| Technical Information | TI No. TI-20240321-EH32 | Page 1 of 4 |
| Applicable Model EH32 XPOWER | Please convey to your <input checked="" type="checkbox"/> AS Director <input checked="" type="checkbox"/> Technical Dept. <input checked="" type="checkbox"/> Warranty Dept. <input checked="" type="checkbox"/> Parts Dept. <input type="checkbox"/> PDI Center <input type="checkbox"/> Sales Dept. | |

Subject: EH32 XPower High-speed Vibration Solution

A AXIS

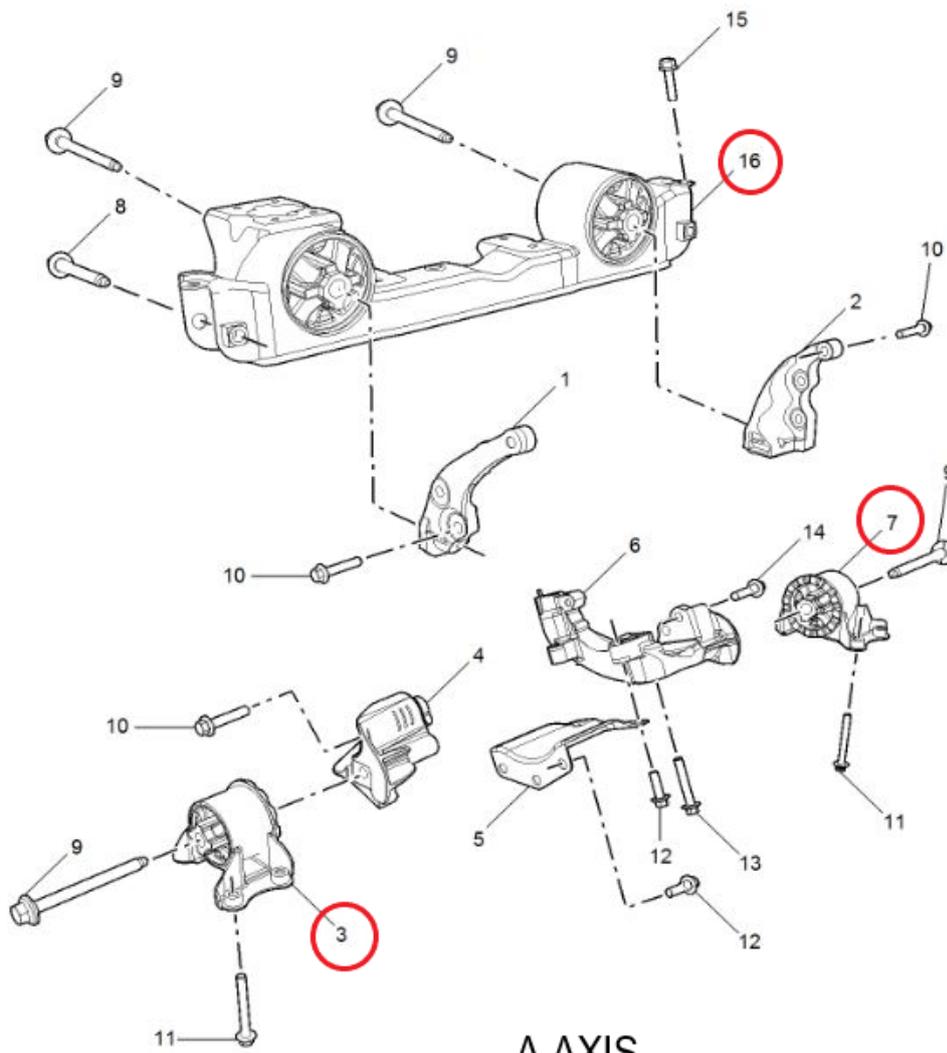
6. After-sales suspension solution:

Note: This repair work requires high technical works and is recommended to be performed only for individual customers who have severe complaints. It is not recommended for after-sales service campaign.

| Part No. | Part Description | Qty | Remark |
| 11634105 | MOUNT ASM-LR | 1 | A AXIS-7 |
| 11634111 | MOUNT ASM-RR | 1 | A AXIS-3 |
| 11768662 | CROSSMEMBER-ENG MT FRT UPR | 1 | A AXIS-16 |

Refer to the operation instructions in the service manual.

B AXIS

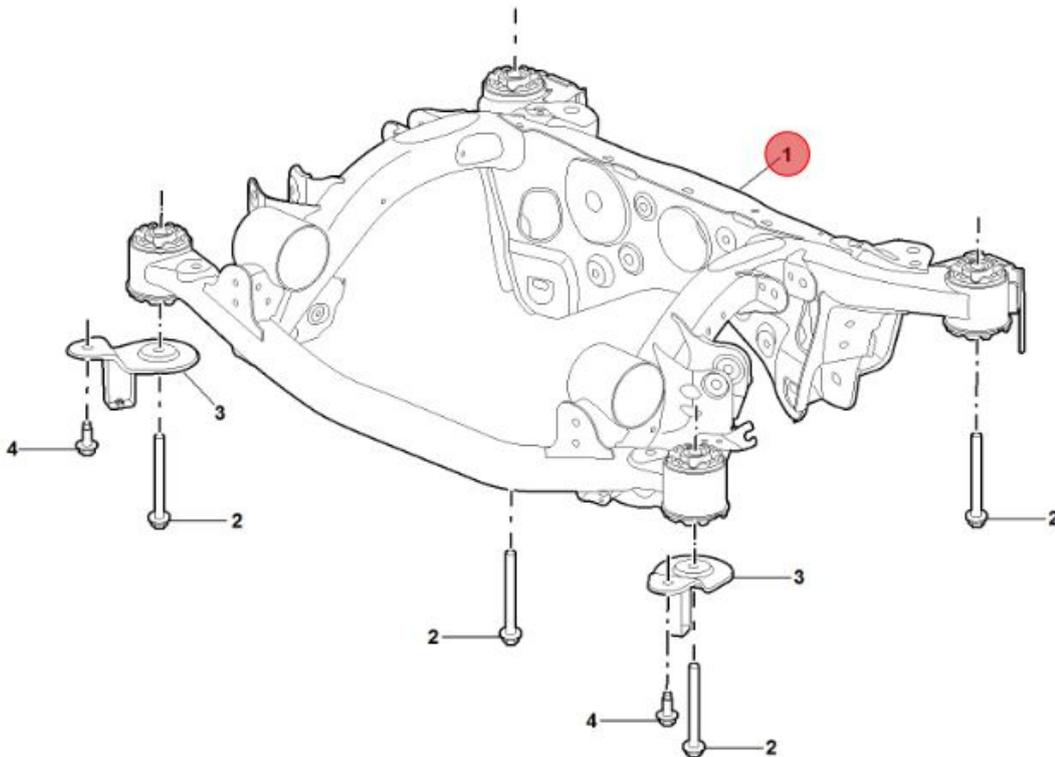
| Part No. | Part Description | Qty | Remark |
|----------|-------------------------------|-----|-----------|
| 11611888 | FRAME ASM-RR SUSP | 1 | B AXIS-1 |
